## ADDENDUM 3

### RFP: Project No. 6776 and 6777 Stormwater System

#### Replacement

**DATE OF ADDENDUM:** February 18, 2025

| Client Project Number<br><b>6777</b> | Client Drawing Number<br>- | Drawing No.<br><b>C201</b> |

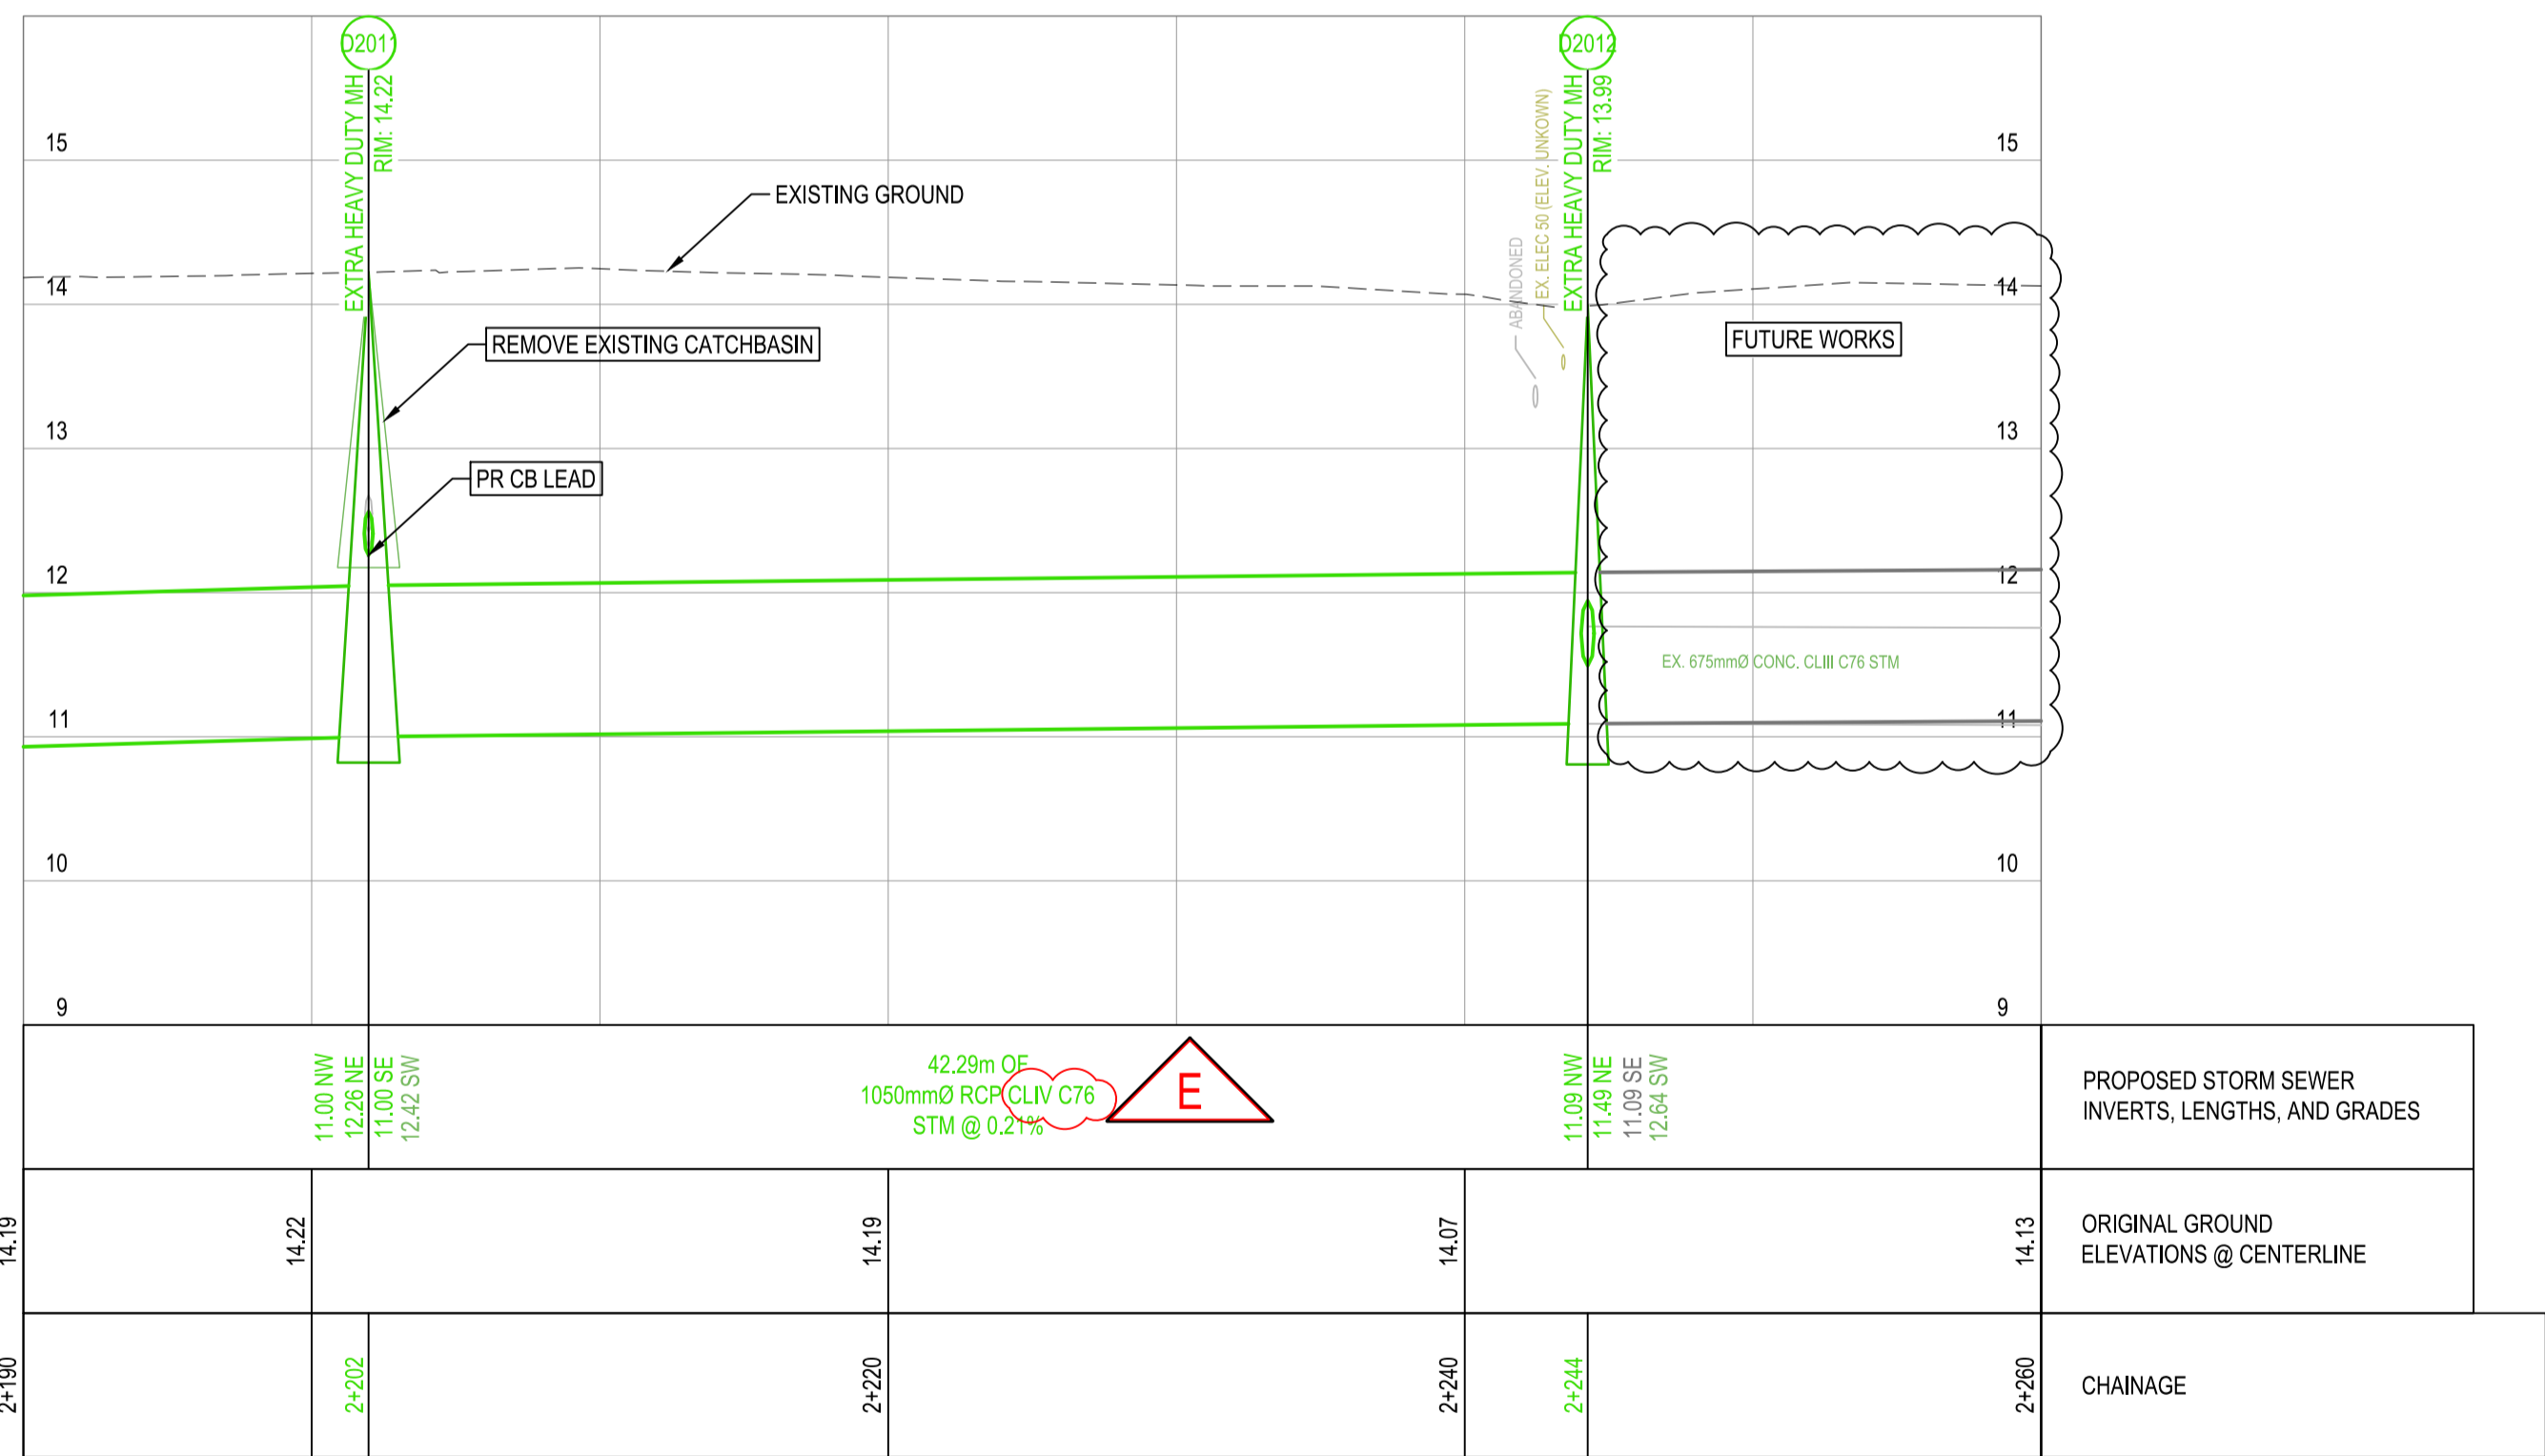
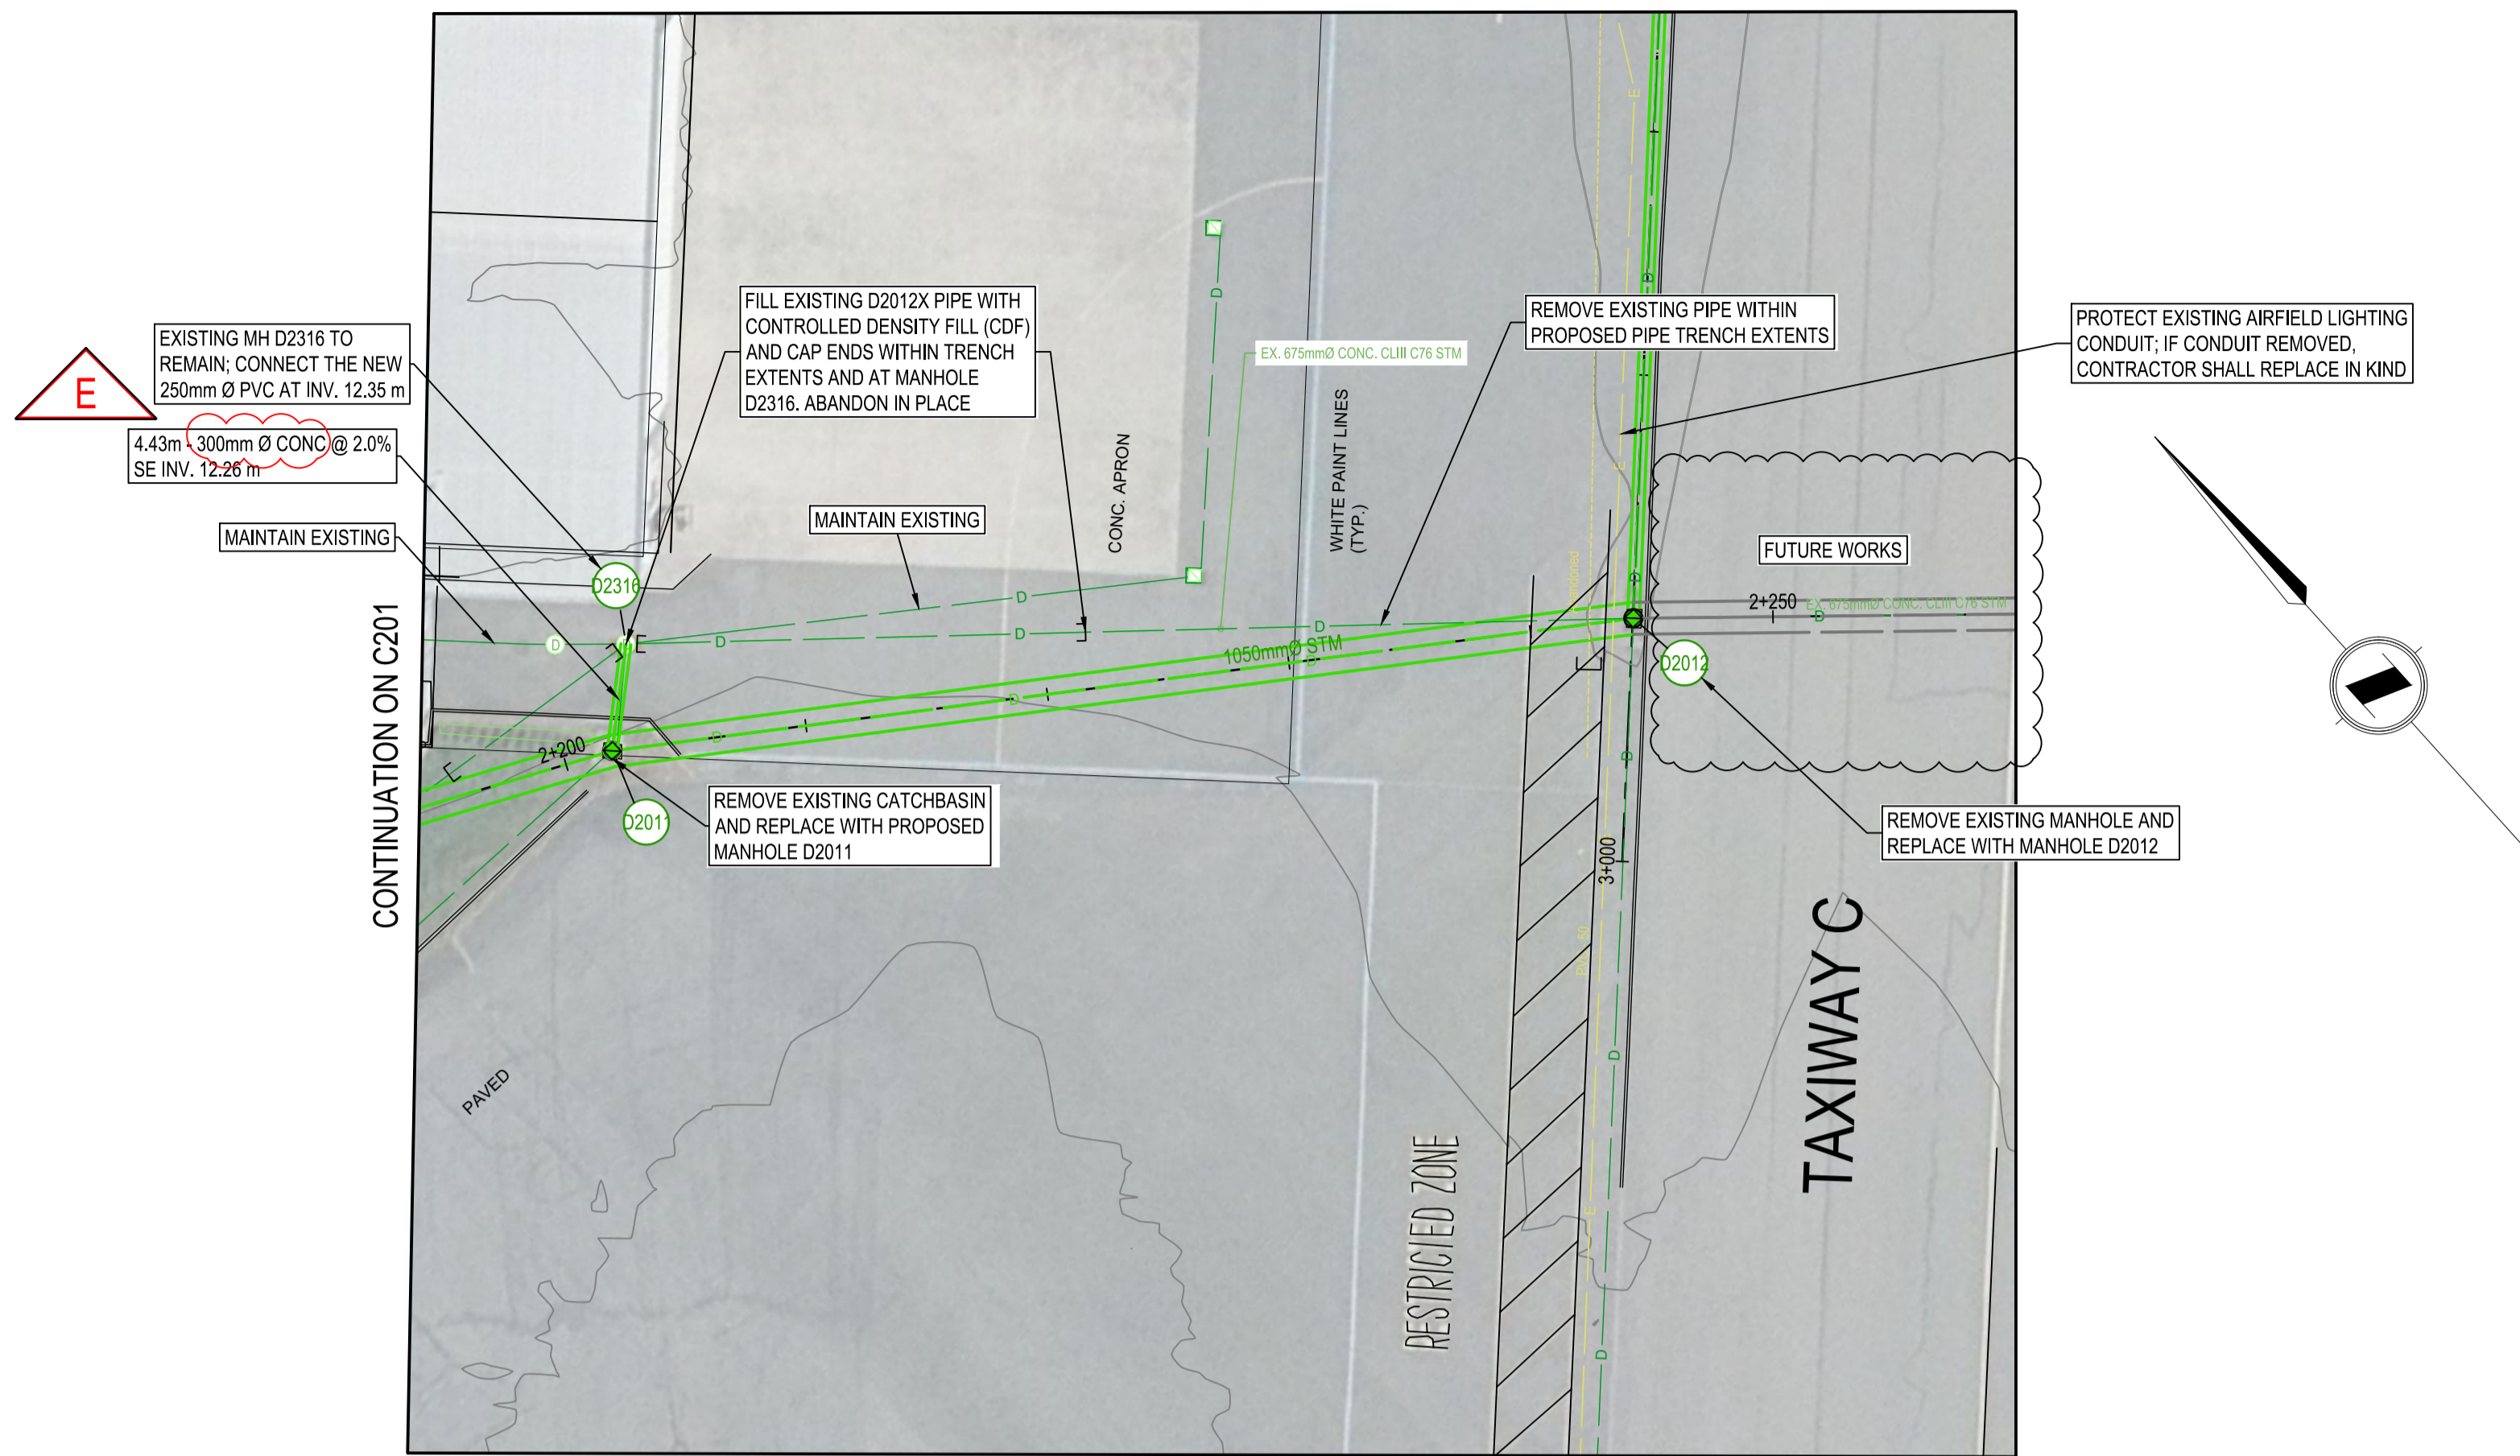
9. Q: For concrete storm pipes, please confirm ASTM C67 class 3 reinforced concrete pipes are acceptable to be used on this project.  
A: All pipes shall be Class III ASTM C76, except for the pipes on the airside. See the revised Form of Tender (FoT) Appendix 1 - Schedule of Quantities and Prices and C6777 Drawings C201 - C203.

- Project No. 6777 C201 (Rev E): Revised pipe material as response to Q9 above.
- Project No. 6777 C202 (Rev E): Revised pipe material as response to Q3 and Q9 above.
- Project No. 6777 C203 (Rev E): Revised pipe material as response to Q9 above.
- Project No. 6777 C502 (Rev E): Revised trench detail as responses to Q12 and Q13 above.
